Project	IEEE 802.16 Broadband Wireless Access Working Group < http://ieee802.org/16 >	
Title	Power Balancing for MIMO Precoder	
Date Submitted	2009-07-15	
Source(s)	¹ Hsuan-Jung Su, Chung-Pi Lee, Yu-Han Yang, Chun-Yao Chen, Wei-Shun Liao, NTU Ren-Jr Chen, Chung-Lien Ho, Chang-Lan Tsai, Zheng Yan-Xiu, ITRI	Voice: ¹ +886-2-33663600 E-mail: ¹ hjsu@cc.ee.ntu.edu.tw * http://standards.ieee.org/faqs/affiliationFAQ.html >
Re:	IEEE 802.16m-09/00028 "Call for Comments and Contributions on Project 802.16m Amendment Content"	
Abstract	This contribution addresses the high PAPR issue related to MIMO precoding and IFFT. It is suggested that a general remedy to the PAPR issue without introducing signal distortion or side information feeding forward should be considered in 802.16m. A method based on constellation shaping to balance the signal power, such that the high PAPR caused by precoding and IFFT can be reduced, is also provided in this contribution as an example of such general remedies.

Power Balancing for MIMO Precoder

Figure 514 -- UL MIMO architecture

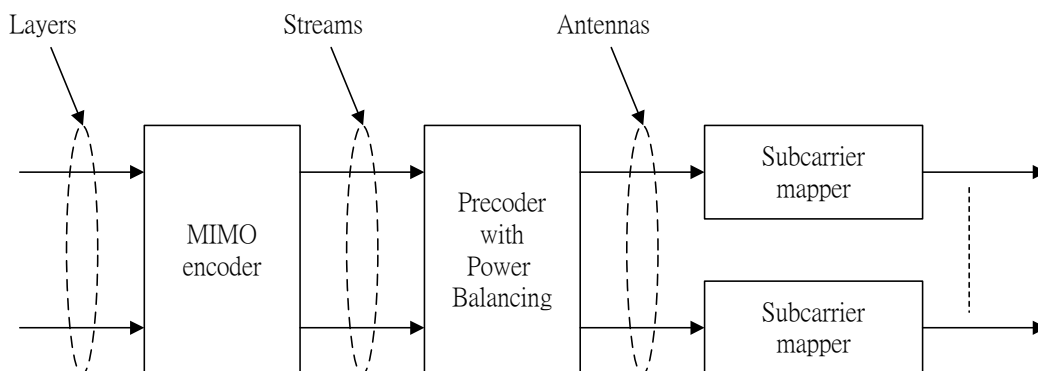
Modify Figure 514 as follows.

Figure XXX – Precoder with Power Balancing

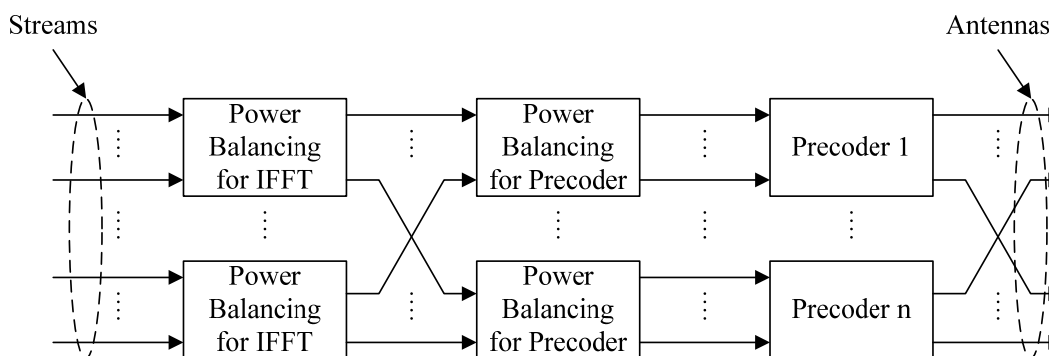
Add the following section on power balancing for the precoder and IFFT.

Power balancing can be performed to alleviate the high peak power problem caused by the precoder and IFFT. The precoder block with power balancing is shown in Figure XXX. The power balancing operations are in the order of power balancing for IFFT first, then power balancing for precoding. Power balancing for precoding is an integer-to-integer mapping which is an approximation of the inverse of the precoding matrix, where integer means Gaussian integer defined on the grid of the signal constellation. For any precoding matrix, the integer-to-integer mapping of the power balancing operation is factorized into a series of Integer Reversible Matrix Mapping (IRMM)
